**CITY OF FLORENCE
PLANNING COMMISSION**

RESOLUTION 03-12-30-41

IN THE MATTER OF A REQUEST FOR APPROVAL OF A MODIFICATION TO THE SANDPINES PLANNED UNIT DEVELOPMENT, A TOTAL OF 242 ACRES, LOCATED NORTH OF 35TH STREET, WEST OF OAK STREET, EAST OF RHODODENDRON DRIVE, MAP REFERENCE 18-12-15, TAX LOTS 400-1000, 1400 &1500, AND 18-12-15-33, TAX LOTS 100&700 AND 18-12-22-21, TAX LOTS 1900 AND 18-12-22 BLOCKS 8, 10-13, 3000-5300, 10900-15100 AS APPLIED FOR BY MYHRE GROUP ARCHITECTS FOR ARIKI-OREGON, LTD.

**Revised Exhibit "A"
Findings of Fact
January 13, 2004
Resolution 03-12-30-41**

SANDPINES RESORT RHODODENDRON DRIVE IMPROVEMENTS TRAFFIC CONTROL PLAN

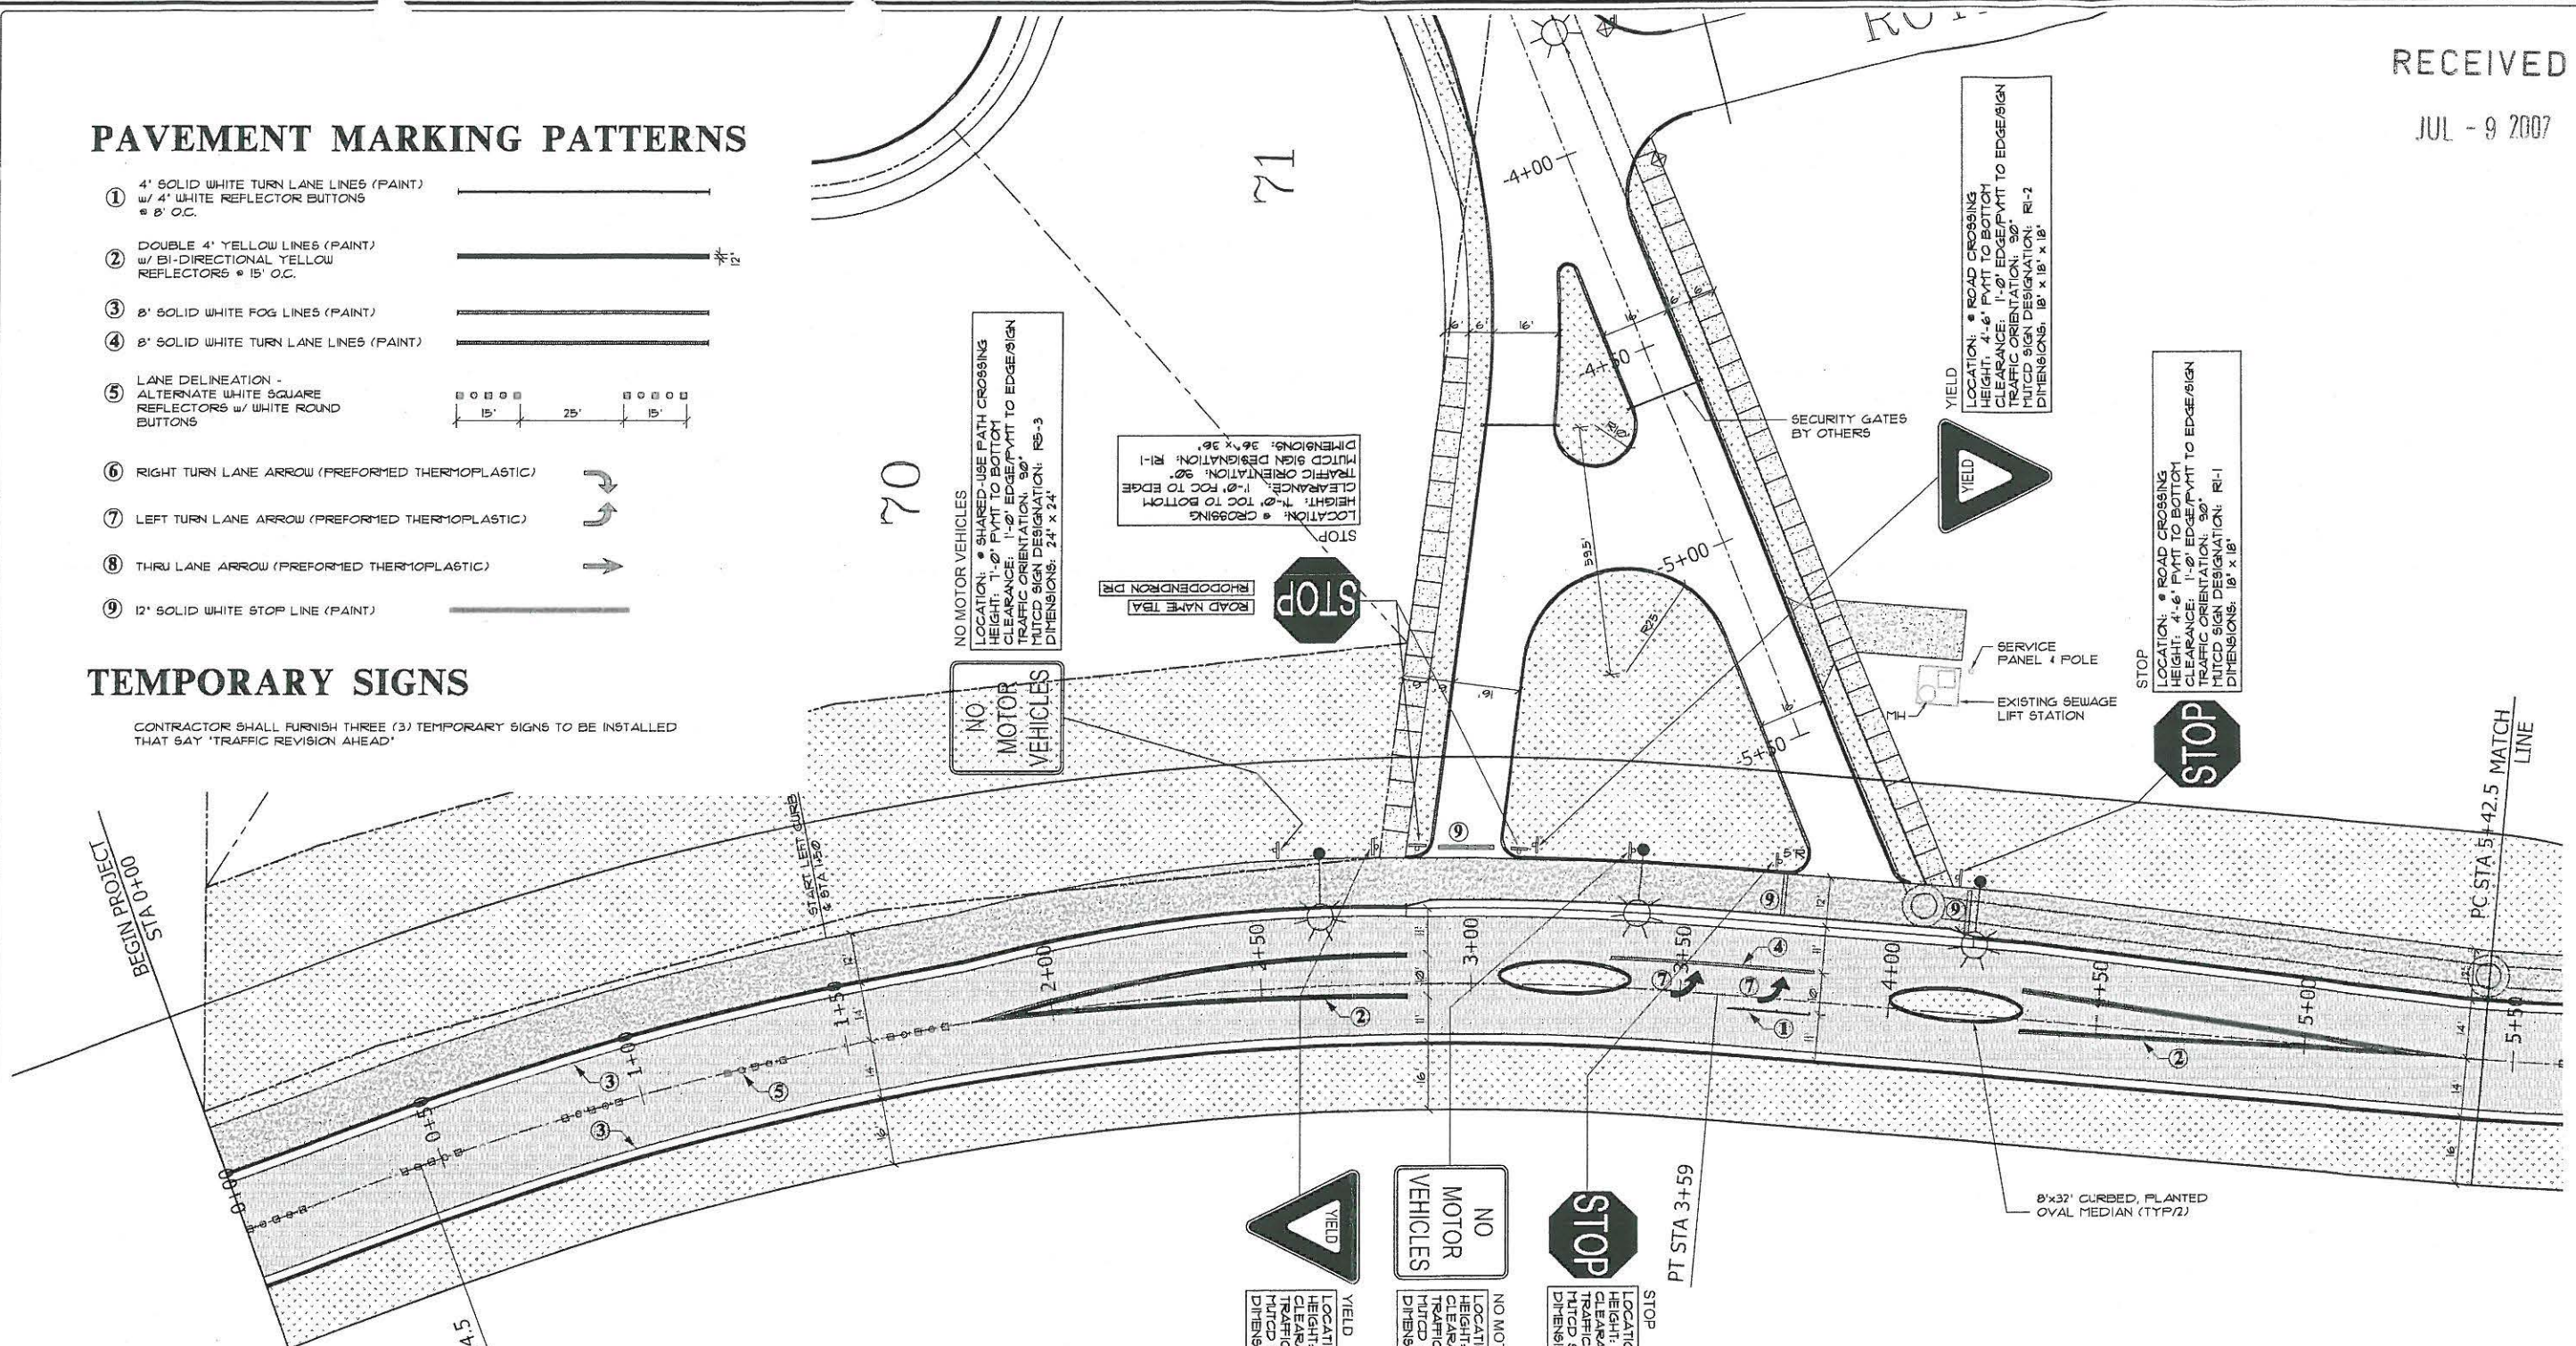
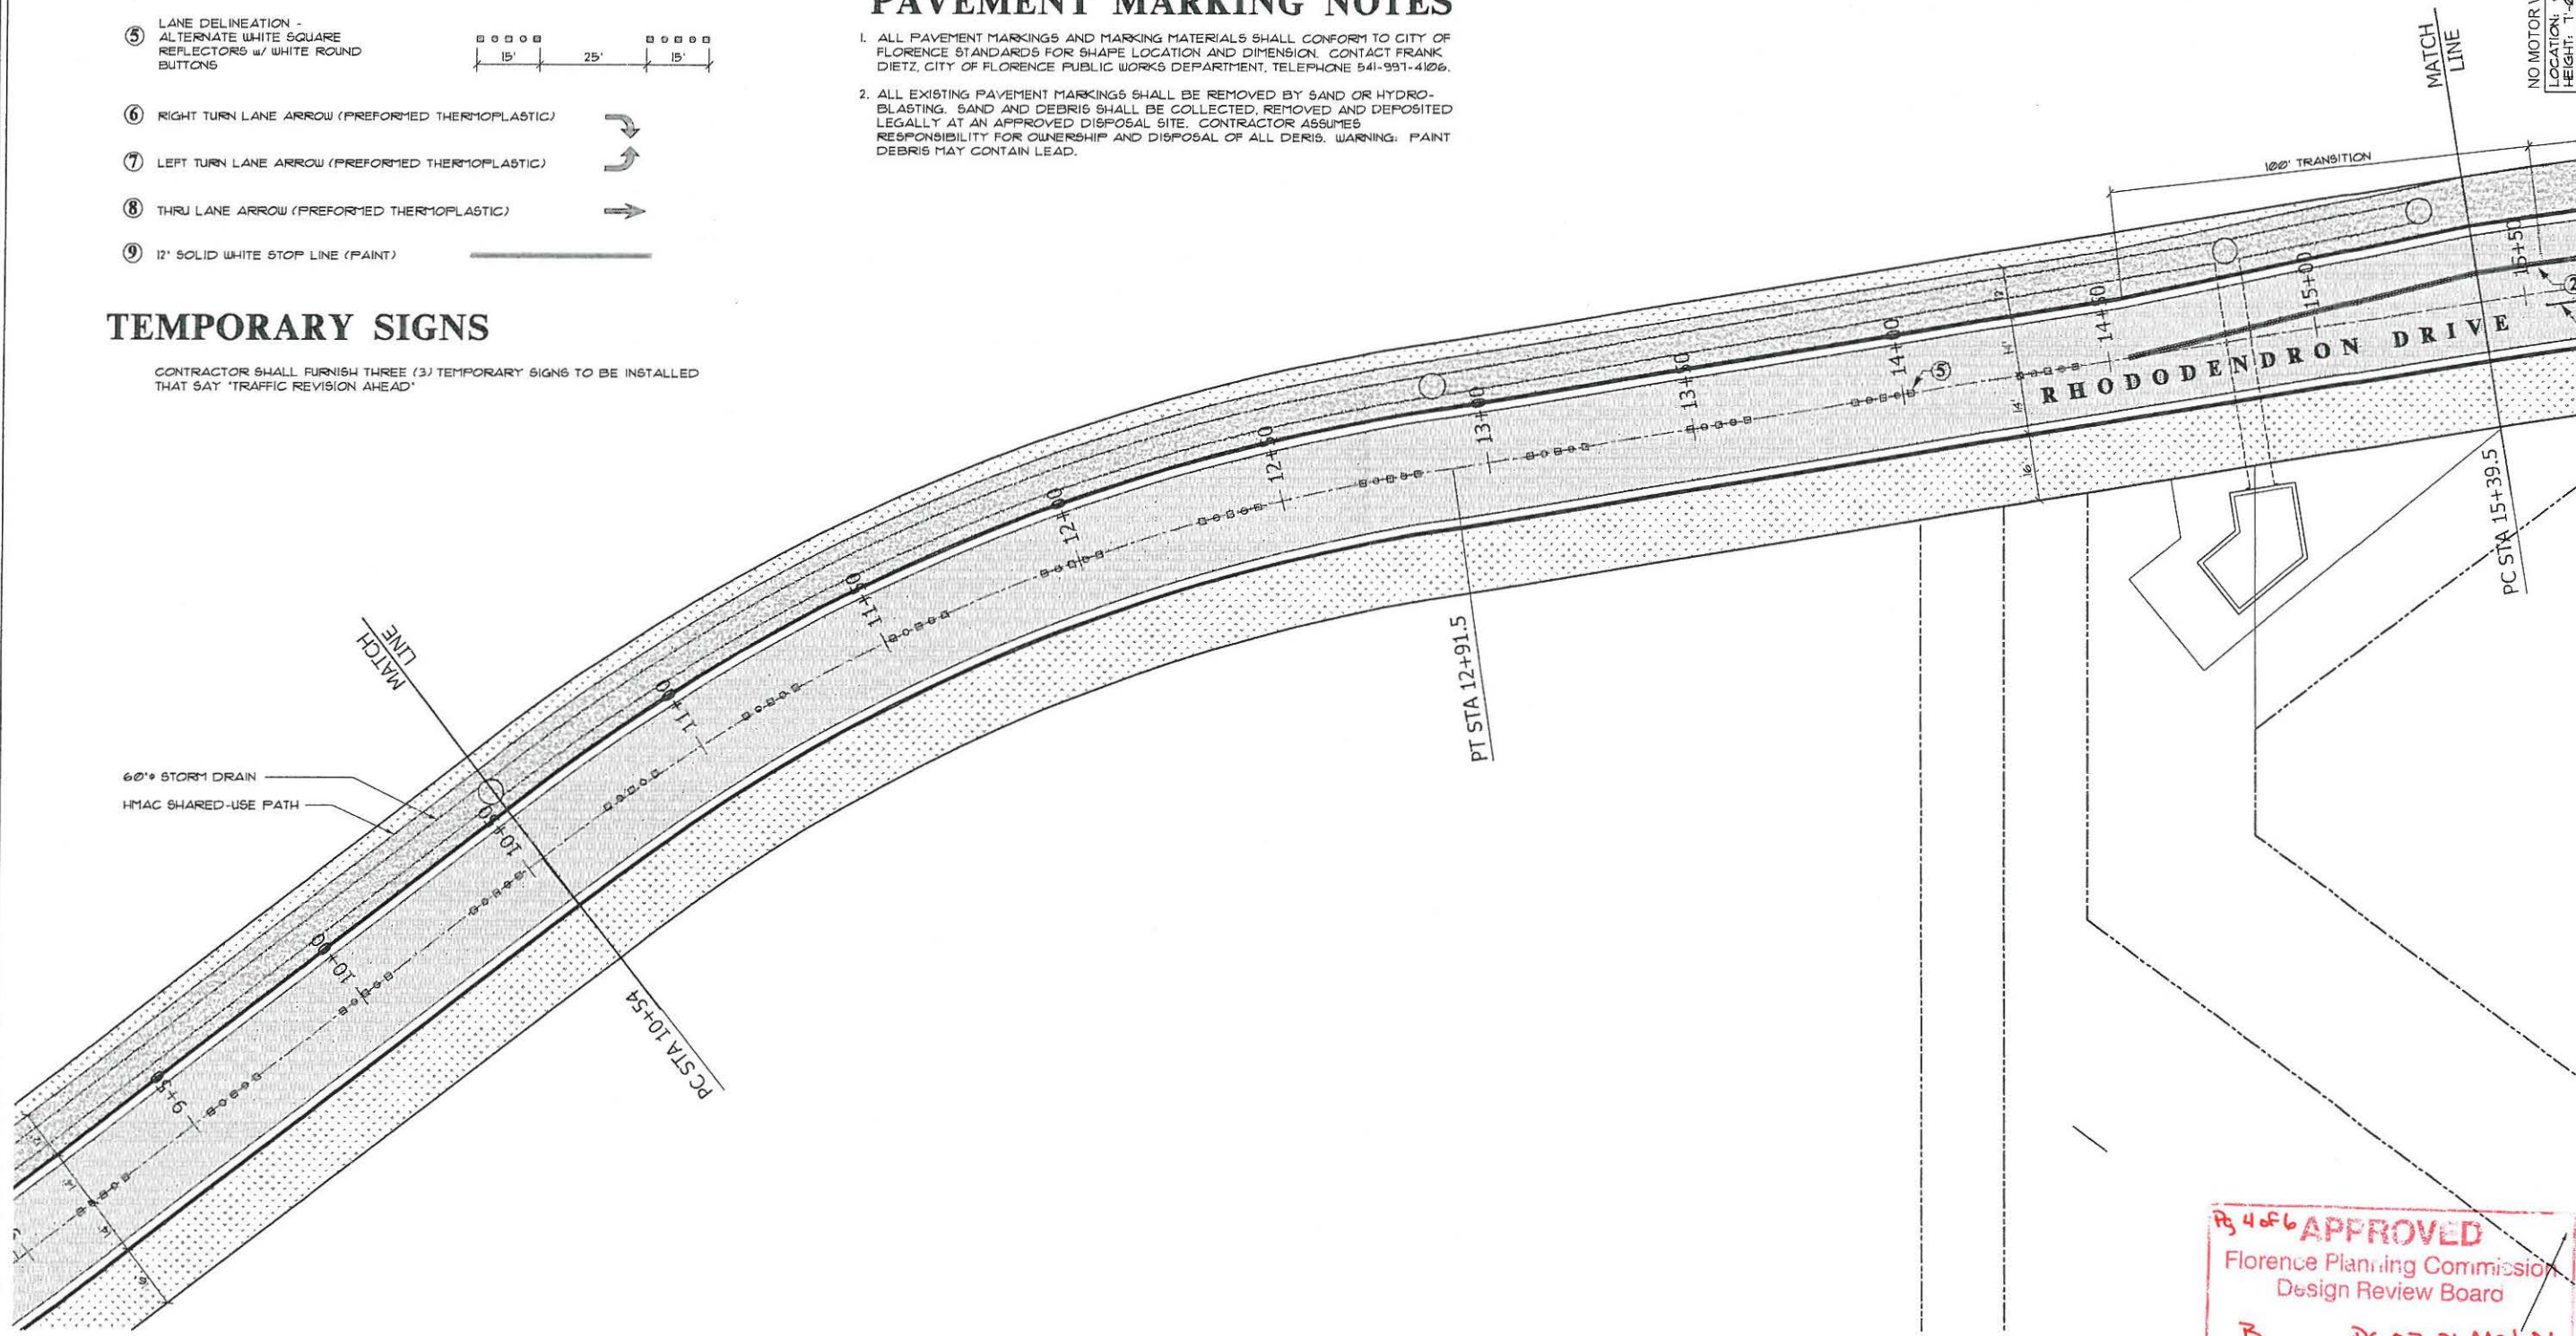
Exhibit B
Modifications to Condition of Approval
Sandpines II and III
Preliminary Traffic Plans
